ENGAGEMENT SUMMARY

SPRINGBANK PARK ESTATES + ROYAL SPRING ESTATES

Date: February 1, 2021

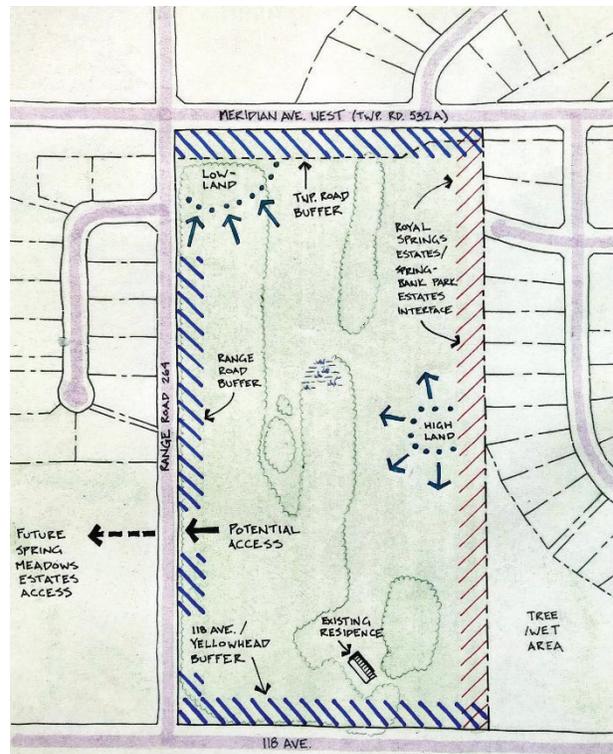
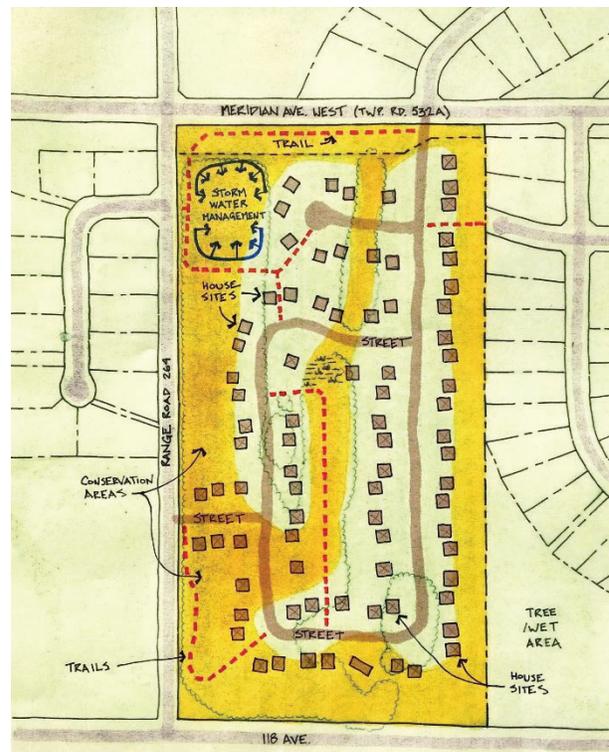
The only question I have is regarding the existing wet land in the middle of the site and how is it going to drain?

The proposed road and residential lots are going to obstruct the natural surface drainage pattern. I am assuming a culvert would be installed at the road so drainage can flow under the road, but then for the surface drainage to get to the constructed wetland, it would have to flow through the residential lots or follow road ditches the long way around and against the existing topography.

Utilizing the existing topography and LID approach, the concept could consider a long linear wetland drainage feature (rain garden, bioswale), connecting the existing wetland to the low part of the site, instead of the typical large constructed wetland.

Response: The conservation (cluster) design approach illustrated in the project vision will be carried forward in the Conceptual Scheme, rezoning, and subdivision application. Grading plan and stormwater management plans will be refined through the planning and development, with the objective of retaining the existing wetland (e.g., directing adequate flows of stormwater to the wetland) while meeting County development standards.
